Access Compliance Report

Public Rights-of-Way

(Curb Ramps)

Intersection ID: 32285	Main Street: ALLYSON_PARK_DR	Cross Street: AUBURN_TOP_LN	Location: NW
ADA ID: FBE0774CCFC2	Ramp Type: PerpDiag	Initial Pass/Fail: Fail	Overall Compliance: No
Severity Score: 10			
Codes/Mitigation Info/Possible Solution		Field Measurements/Component Compliance

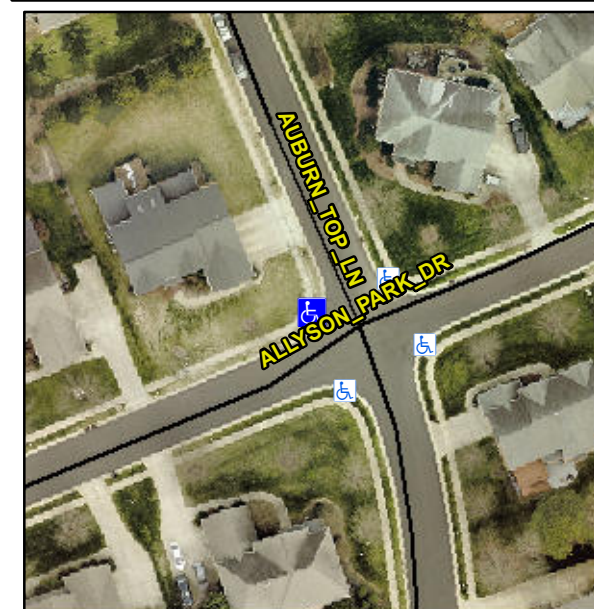
Not Found, R304.5.1, R304.5.3

Compliance	Description	Data	Compliance	Description	Data
N/A	Ramp Length (in)	51.0	Yes	Ramp Slope (%)	7.5
No	Ramp Width (in)	44.0	No	Ramp XSlope (%)	3.4
N/A	Flare Type LT	N/A	N/A	Flare Type RT	N/A
N/A	Flare Slope LT (%)	N/A	N/A	Flare Slope RT (%)	N/A
N/A	Flare Traversable LT?	N/A	N/A	Flare Traversable RT?	N/A
N/A	Landing Length (in)	N/A	N/A	DWS Provided?	N/A
N/A	Landing Width (in)	N/A	N/A	DWS Contrast?	N/A
N/A	Landing Slope (%)	N/A	N/A	DWS Length (in)	N/A
N/A	Landing X Slope (%)	N/A	N/A	DWS Full Width?	N/A
N/A	Landing Curb? (Y/N)	N/A	N/A	DWS Offset (in)	N/A
N/A	Shared Landing?	N/A			
N/A	Gutter Ponding?	N/A	N/A	Gutter Slope (%)	N/A
N/A	Gutter Lip Ht (in)	N/A	N/A	Gutter X Slope (%)	N/A
N/A	Painted X Walk1?	No	N/A	Painted X Walk2?	No
	X Walk 1 Direction	To S		X Walk 2 Direction	To E
N/A	X Walk 1 Width (in)	N/A	N/A	X Walk 2 Width (in)	N/A
	X Walk 1 Slope (%)	1.5		X Walk 2 Slope (%)	0.3
	X Walk 1 X Slope (%)	2.0		X Walk 2 X Slope (%)	0.4

Remove & Replace Curb Ramp With Two New Directional Ramps or Equivalent.
